# SERVICE BULLETIN

**Service Bulletin No.:** DA20-27-01, Rev. 0

**Title:** Flap Actuator

Figure 1. Current Limiter Mounting

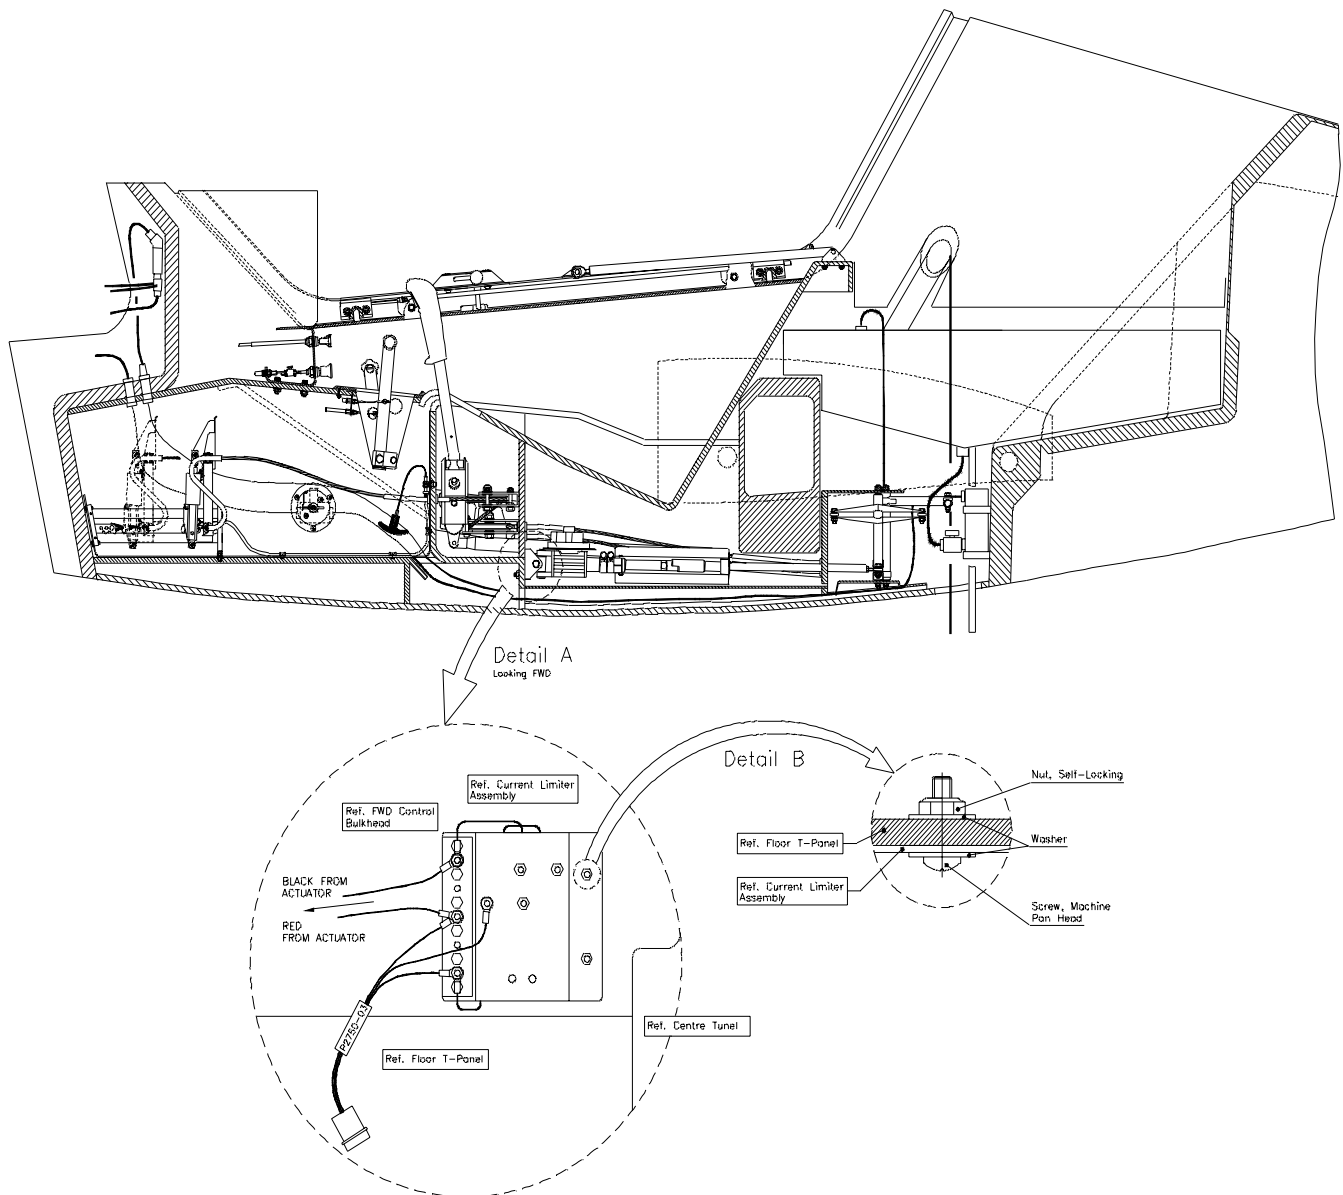
- 11.5 Re-install AN4-16A bolt to secure actuator.
- 11.6 Drill 0.125" diameter holes for the current limiter in the forward control bulkhead, locating them in accordance with Figure 1.

- 11.7 Secure current limiter with hardware supplied as per Figure 1.
- 11.8 Connect motor wires and current limiter wires in accordance with Figure 2 and fasten loose wires with tie-wraps.

Figure 3. Flap Limit Switch Tray

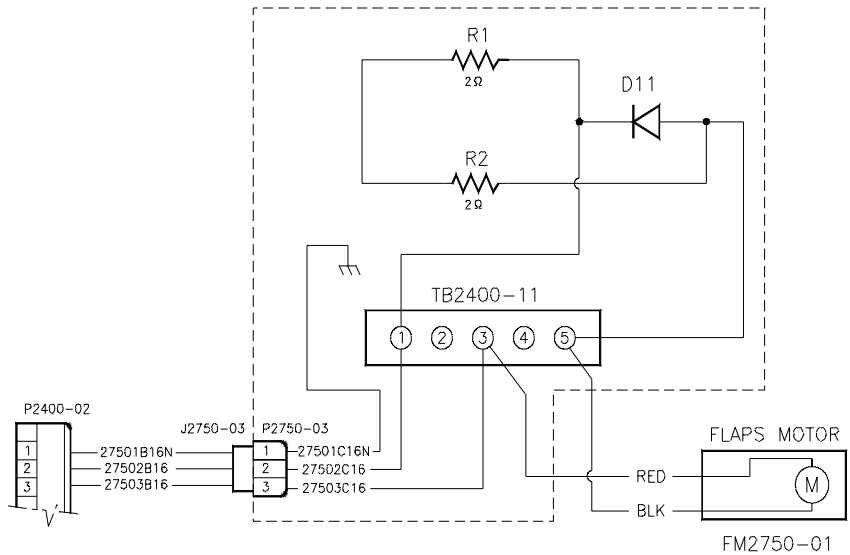
- 11.10.10 Retract flaps to cruise position and check flap pre-load.
  - 11.10.11 If pre-load is above limits, loosen gear clamps on flap limit switch tray and move tray slightly forward. If preload is below limits move tray slightly aft, refer to Fig. 3.
  - 11.10.12 Recheck flap readings.
  - 11.10.13 If any readings are out of limits, adjustments can be made by moving the appropriate individual limit switch (Figure 3).
- 11.11 Cycle flaps and check current limiter voltage in accordance with Maintenance Manual Sub-Chapter 27-50.
- 11.12 With flaps in cruise (UP) position, readjust flap up-stop so that washers can still be rotated by hand.
